PERSIMMON HOMES THAMES VALLEY
NORTH LITTLEHAMPTON
FITZALAN LINK S278 WORKS
LITTLEHAMPTON, WEST SUSSEX

STAGE 1 - ROAD SAFETY AUDIT
ADDENDUM

Project Code:	S/PHFITZ.1.1AD.6a
Prepared by:	Martyn Parr
Approved by:	John Reid
Issue Date:	August 2017
Status:	FINAL

project
**NORTH LITTLEHAMPTON PHASE 2
FITZALAN LINK S278 WORKS**

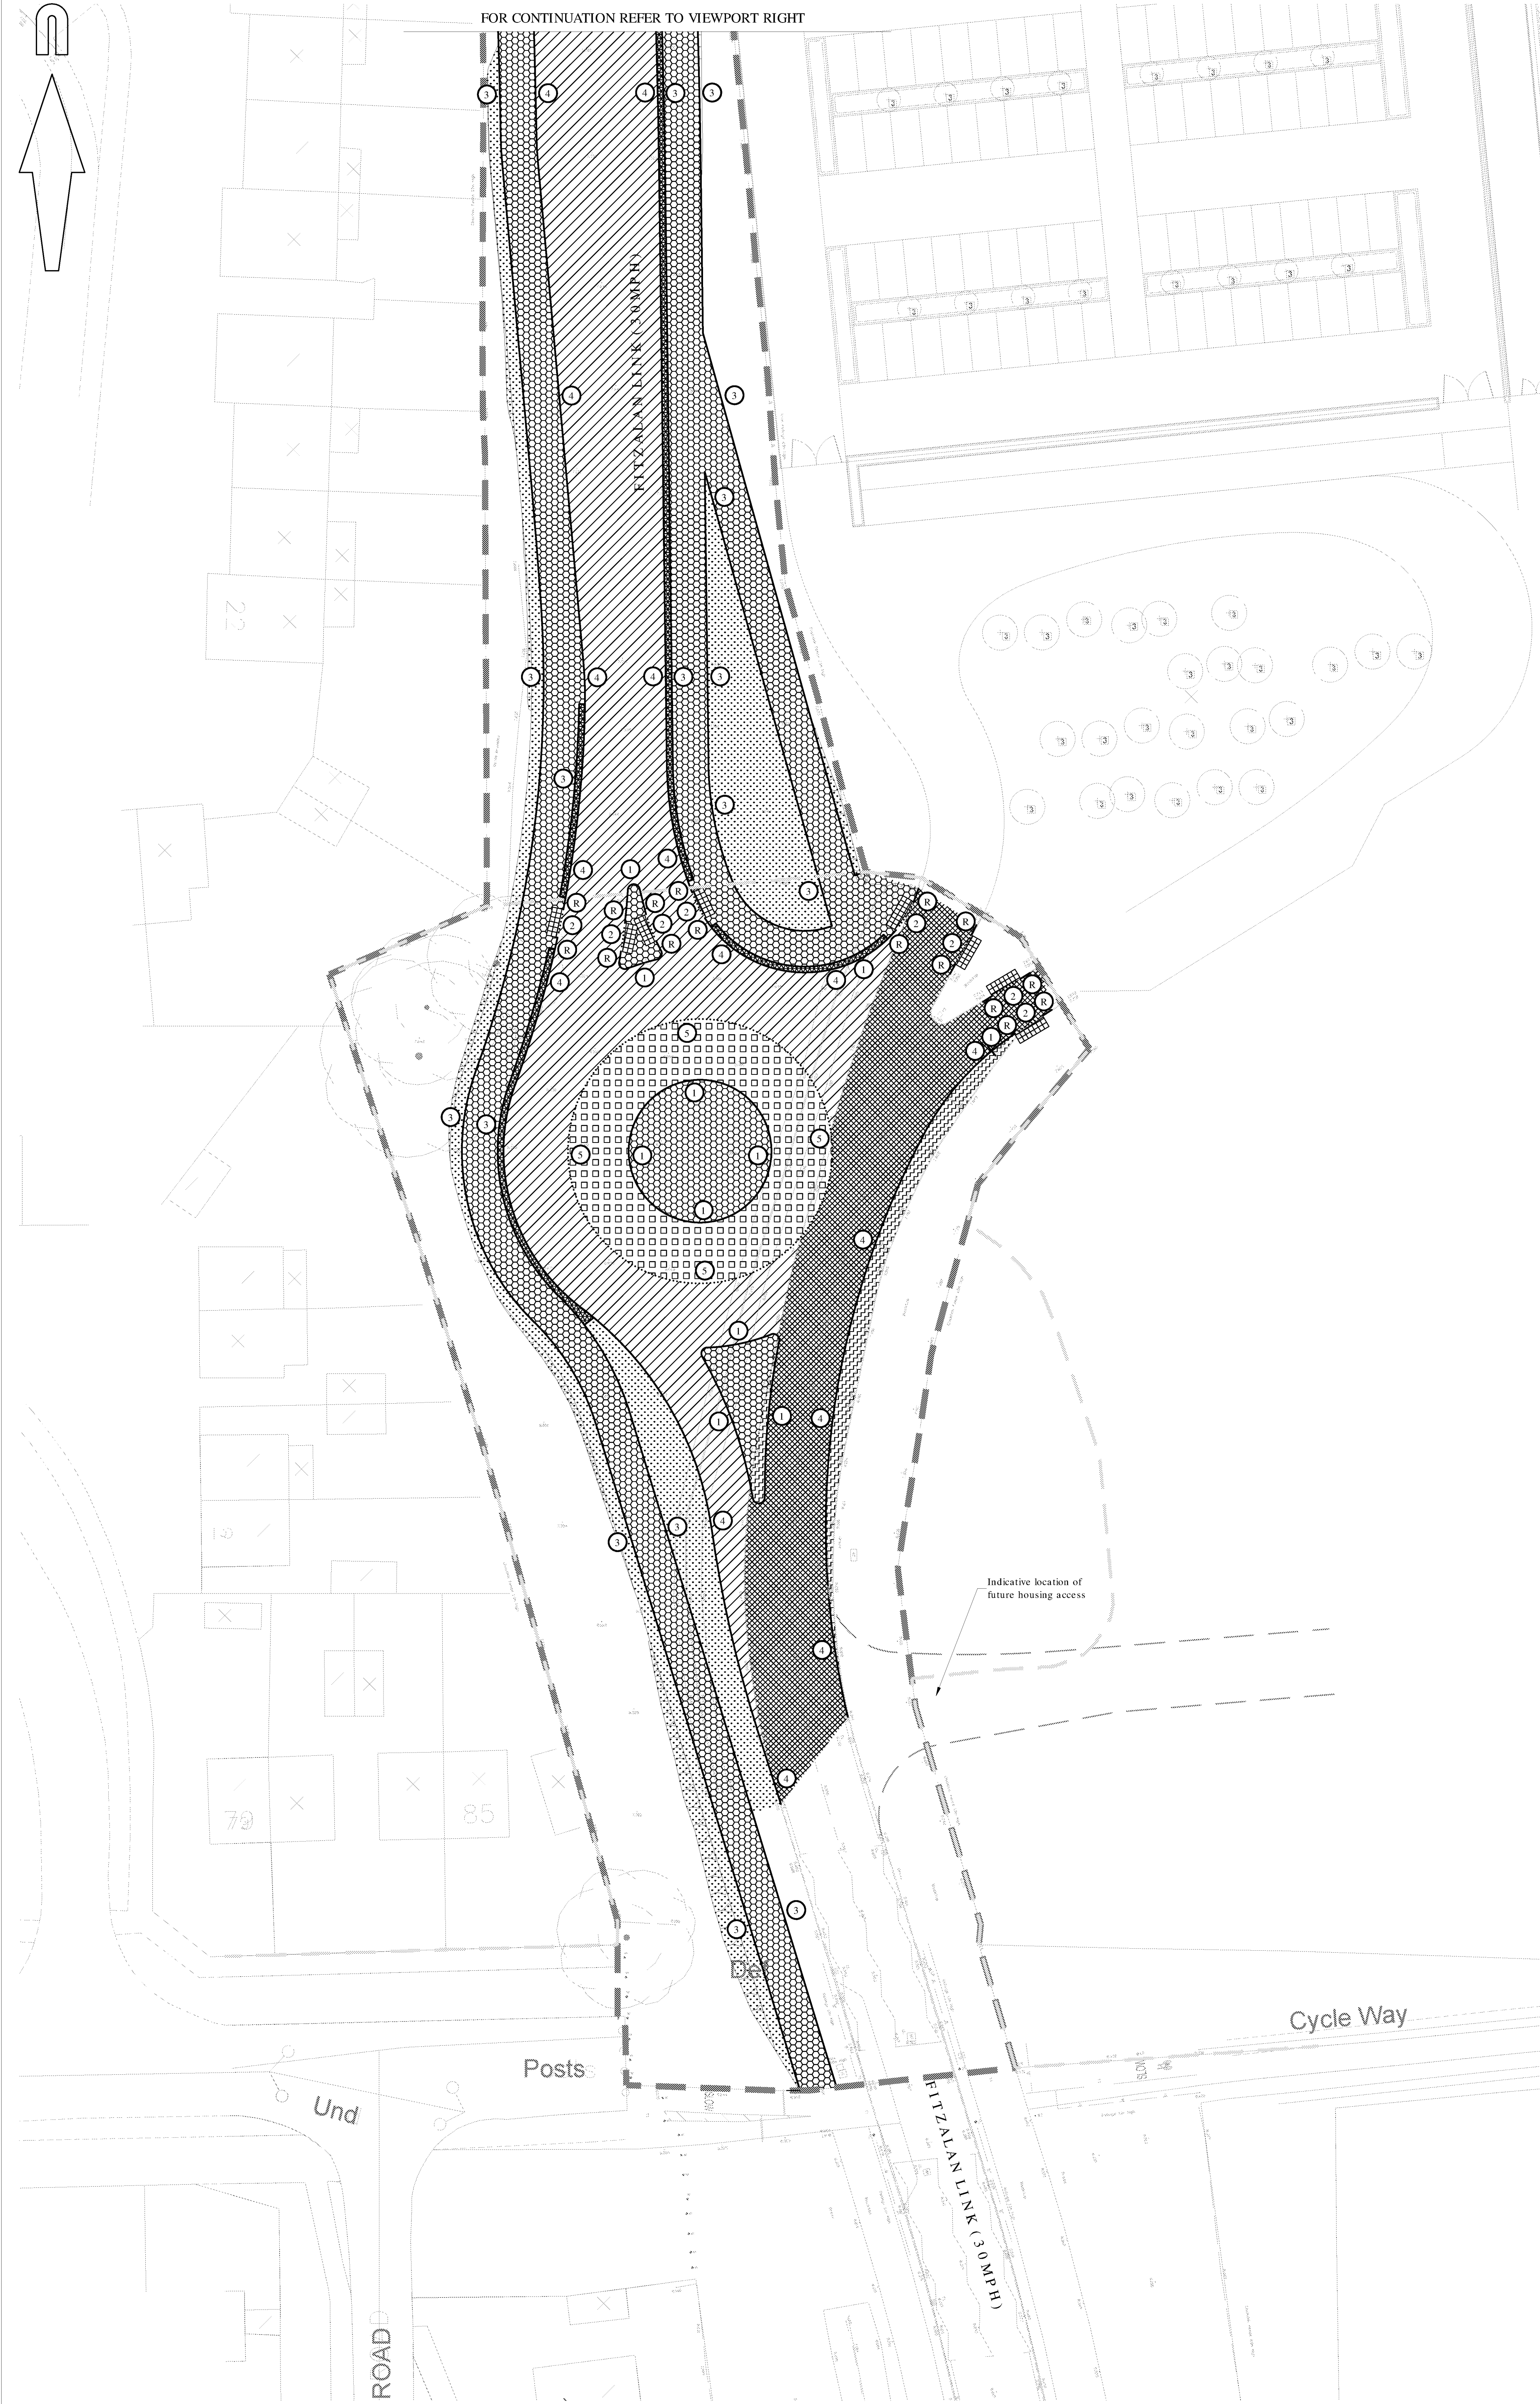
Location: Fitzalan Link Road (please refer to reference point 2.5 in Appendix B)

Summary: Incorrect roundels provided on traffic island

The traffic bollards to be provided on the proposed traffic island will have plain face roundels, indicating that vehicles can pass either side of the island. This could result in vehicles passing the island on the offside resulting in a head on type collision with an oncoming vehicle.

Ensure 'keep left' roundels are provided on the proposed traffic bollards.
